LINCOLN/LANCASTER COUNTY PLANNING COMMISSION STAFF REPORT

APPLICATION NUMBER Change of Zone 05061D	FINAL ACTION? No	DEVELOPER/OWNER Nebraska Horsemen's Benevolent and Protective Association
PLANNING COMMISSION HEARING DATE March 17, 2021	RELATED APPLICATIONS None	PROPERTY ADDRESS/LOCATION S. 1 st Street & W. Denton Road

Change of Zone #: CZ05061D
Southwest Village PUD
S 1st St & W Denton Rd

Exhibit "B"
B-2 Casino Area Signage Plan

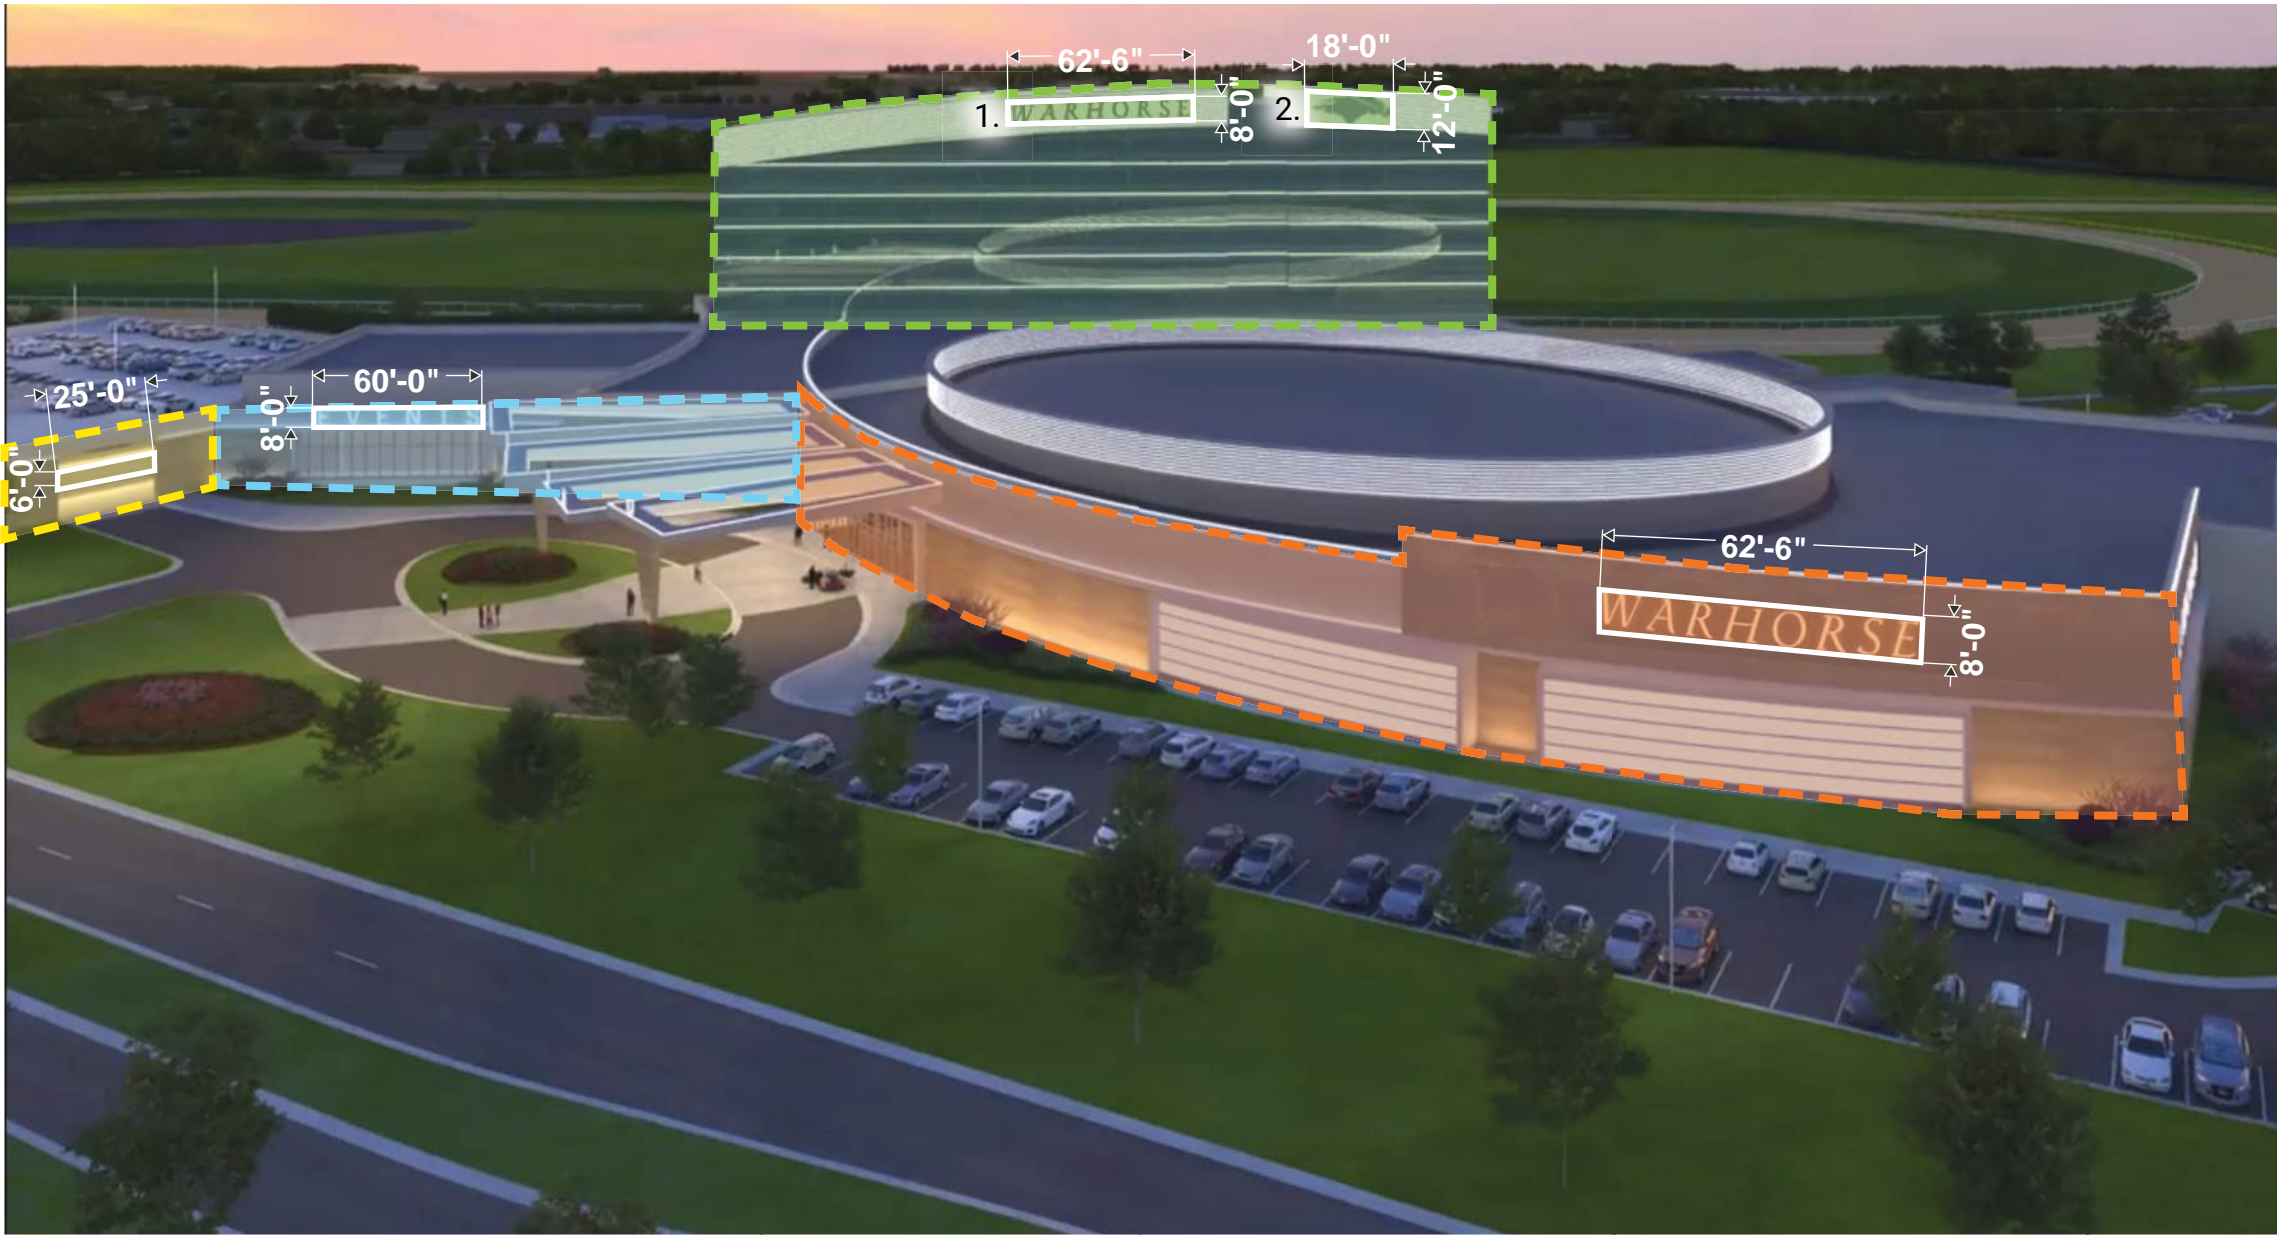
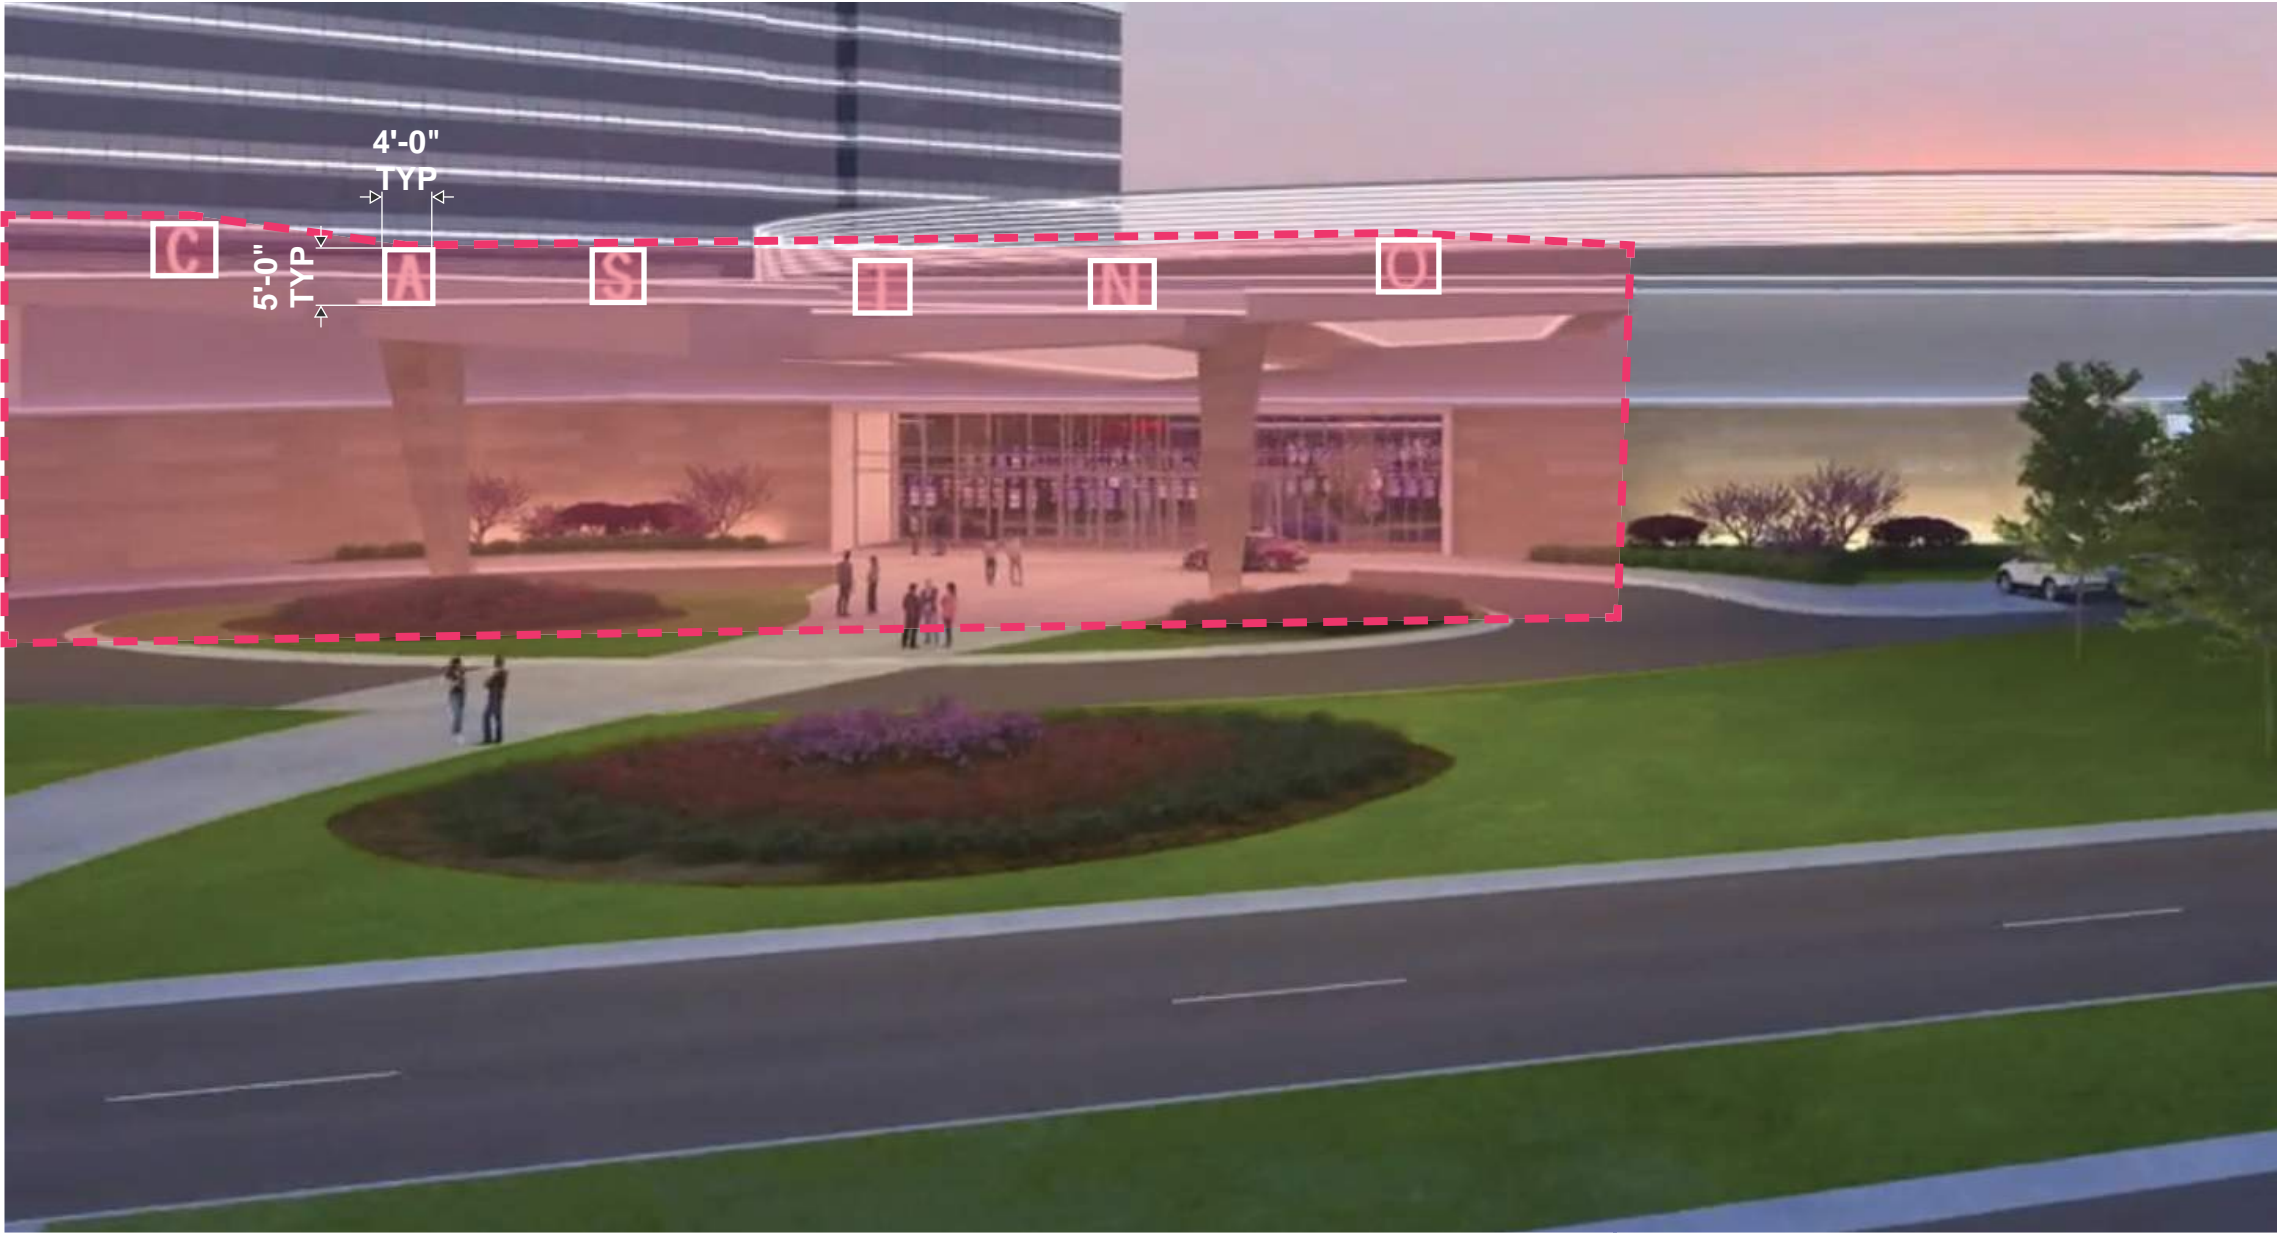
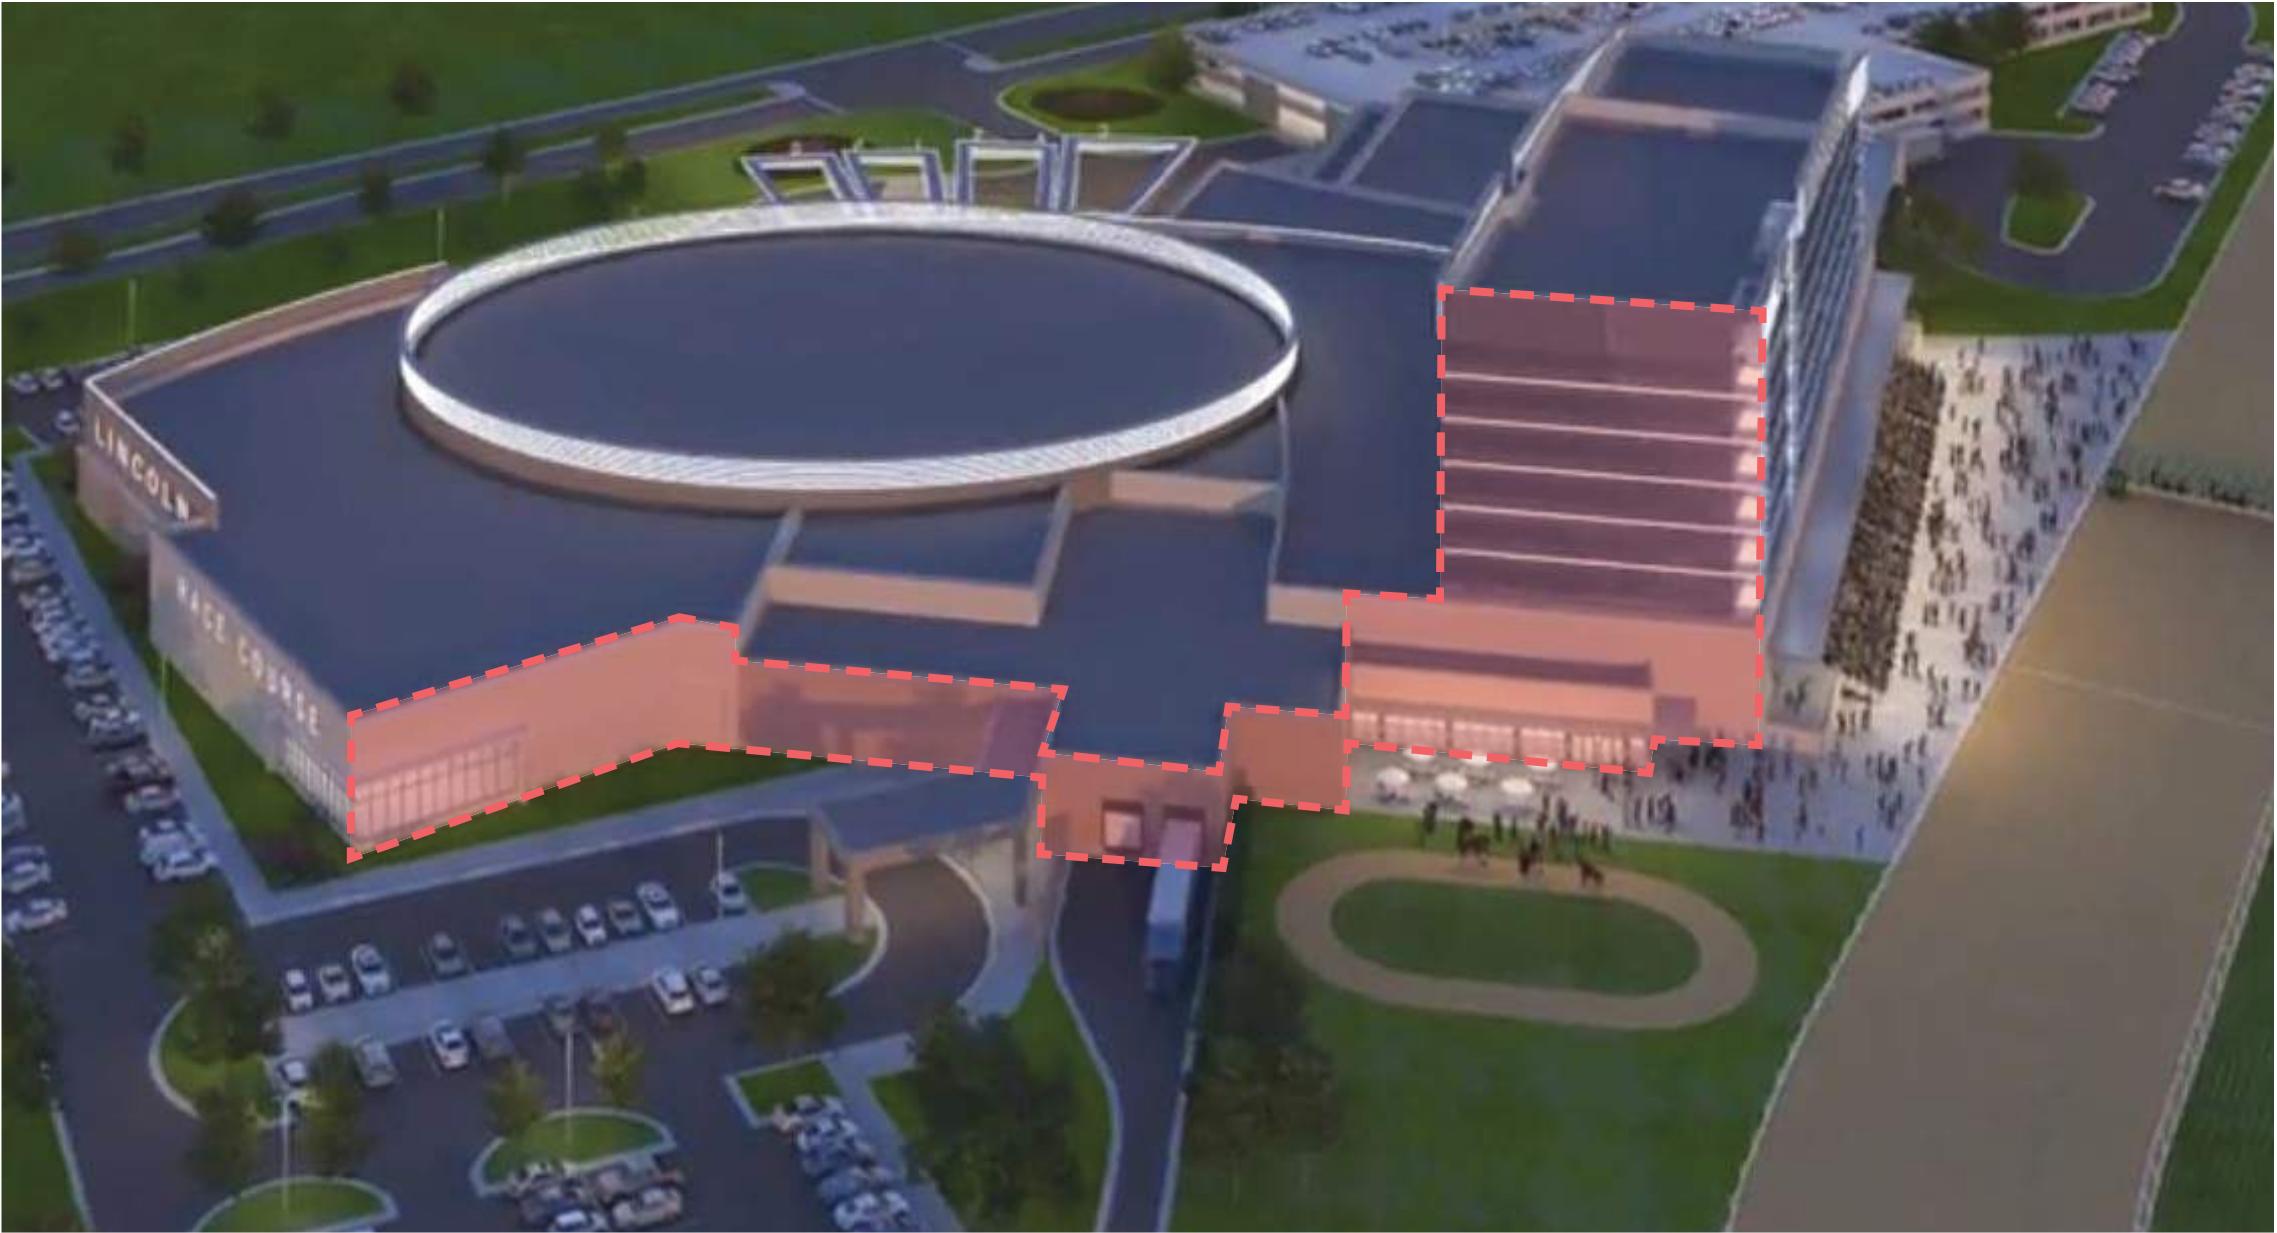
- 2.1 Submit the full amended plan set including sheets that were not changed, remove bubbling and strikeouts on the Cover Sheet notes.
 - 2.2 Revise the sign plan to reflect a maximum of 320 square feet of electronic changeable copy sign area for the 500 square foot center sign. For the center sign, delete the "FACE SF" and "30% FACE SF" categories in the table.
